Please see answers below to RFI's that I have received to date:

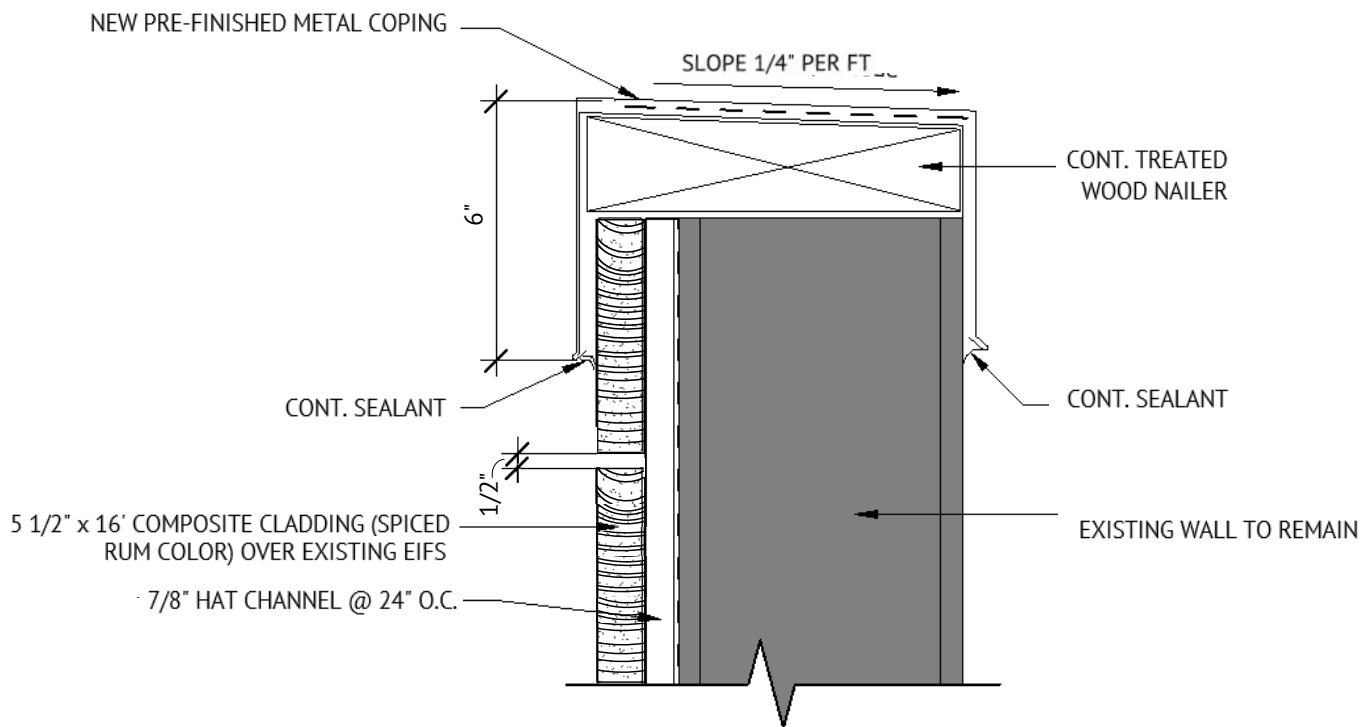
There are four ramps shown on the sidewalk on Mesquite Street (C3.0). Only one is scheduled to be demoed (C2.0). Note 19 on C3.0 calls out three ramps to be TAS compliant. Have the three ramps that are not scheduled to be demoed been field verified to be in compliance? Or do I need to plan on removing/replacing all four or these ramps?

Please budget to remove them. However, we will not know if they are acceptable until the RAS reviewer reviews the plans.

TYP. PARAPET/COPING DETAIL

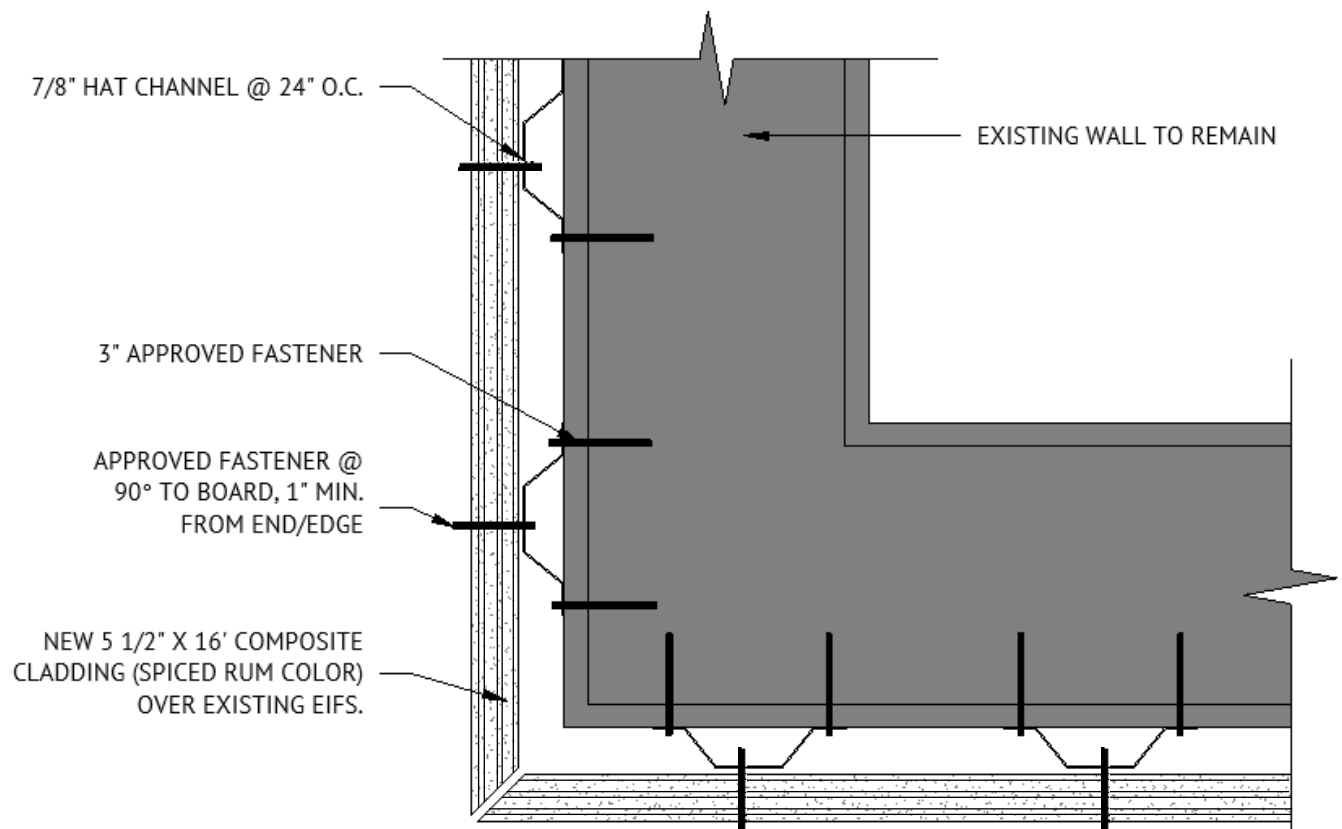
Please provide details for Trex Cladding

See details provided below.

Liquid applied water proofing is to be installed at the Trex/Hat Channel/ EIFS conditions
